Entergy Nuclear Operations, Inc.  
Pilgrim Nuclear Power Station  
600 Rocky Hill Road  
Plymouth, MA 02360

SUBJECT: Pilgrim Nuclear Power Station's Notification of Full Compliance with  
Order EA-12-051, Order Modifying Licenses with Regard to  
Requirements for Reliable Spent Fuel Pool Instrumentation

PNPS Letter 2.15.051

**NRC Audit Questions and Status**

**SIMPLIFIED DIAGRAM SHOWING THE INDEPENDENT NORMAL POWER SUPPLIES AND THE INDEPENDENT BACKUP BATTERIES**

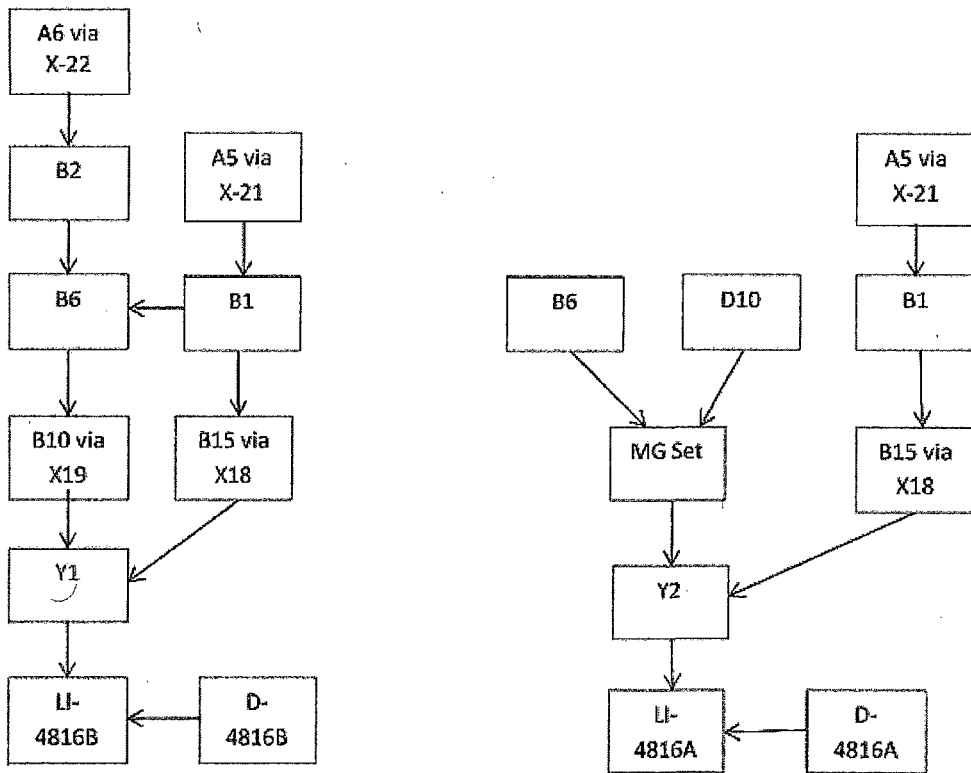
- f. Power supplies: Permanently installed instrumentation channels shall each be powered by a separate power supply. Permanently installed and portable instrumentation channels shall provide for power connections from sources independent of the plant AC and DC power distribution systems, such as portable generators or replaceable batteries. Onsite generators used as an alternate power source and replaceable batteries used for instrument channel power shall have sufficient capacity to maintain the level indication function until offsite resource availability is reasonably assured.**

Per References 8 and 10, the two PNPS SFP instrument loops are powered from opposing power AC power sources. Power is supplied for one loop (LI-4816B) from 120 VAC Panel Y1. Power is supplied for the other loop (LI-4816A) from 120 VAC Panel Y2.

The two PNPS SFP instrument channels incorporate independent plant power sources [not only originating from different buses (NEI 12-02 required) but also from different power divisions (NEI 12-02 preferred) as well as incorporating loop-specific stand-alone backup battery power of sufficient capacity (NEI 12-02 acceptable in and of itself coupled with power restoration strategy)]. The permanently installed replaceable and rechargeable backup batteries are configured for an analyzed seven-day capacity. A third power alternative is available per external connections and cables included for each battery panel supplying each SFP processor/display panel to permit powering the system from an external DC source independent of plant sources.

As such, the SFP instrument loops have highly reliable power sources, originating from separate power sources, with power capability independent from plant sources, and with on-board battery capacity analyzed for full event duration (e.g., seven days) or maximum offsite resource availability time frames which is well beyond FLEX strategy restoration time frames. An installed alternate power source is provided for instrument loop power with sufficient capacity to maintain the level indication function for full event duration including until offsite resource availability is reasonably assured.

**Drawing E304 (partial)**

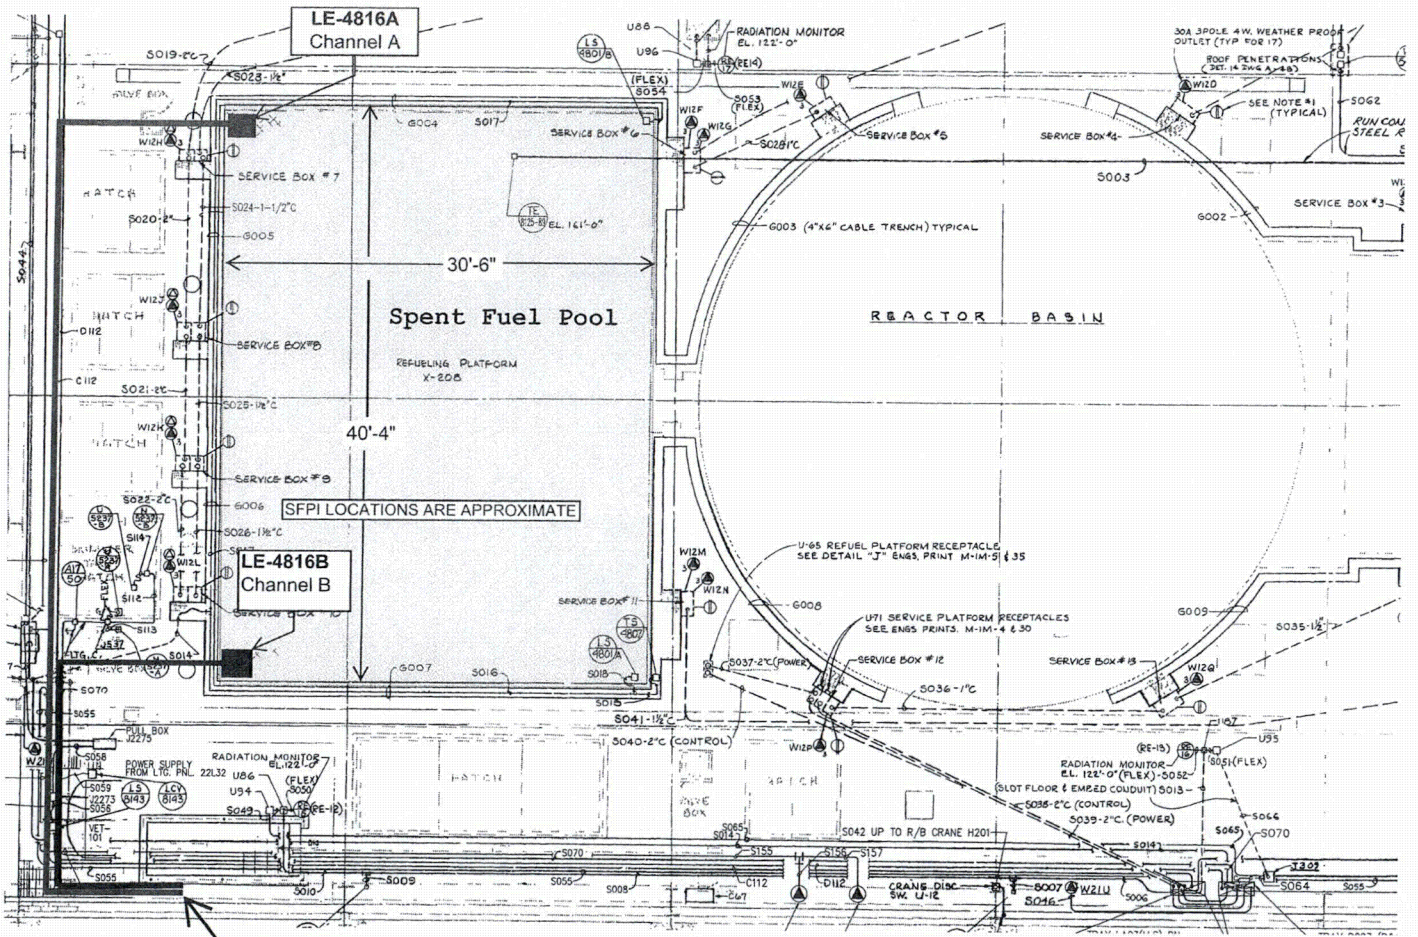
Audit item no.	Original Document Reference	Item	Status
<b>D.</b>		<b>Order 051-SFPI ISE RAIs</b>	
1-D	SFPLI RAI 1	Provide plan view of SFP area showing SFP inside dimensions, planned locations/placement of primary and backup SFP level sensor, and proposed routing of cables that will extend from these sensors toward location of display device.	<p><b>CLOSED</b>                      Attachment 4 provides a plan view of the proposed locations of the probes.                      The SFPI conduit is routed to exit the Refuel Floor, elevation 117 ft. as soon as possible to minimize the possibility of physical damage to both loops from damage due to potential debris during a beyond design basis external event. The Channel A conduit will be installed on or very close to the floor at the west wall until it exits the refueling floor. The Channel B conduit will be installed at a higher elevation above the refueling floor in the southeast corner until it exits the refueling floor.                      NRC Staff performed tour of site on October 2014 and verified there is adequate separation between the cables and the cables are protected against internal missiles.                      See Attachment 5 to this letter for a drawing showing the layout.</p>

Down to 91' (Ref.: E303)  
 continues to Main Control Room - LI-4816A and LI-4816B  
 (Ref.: E298, E301, E303, and E313)
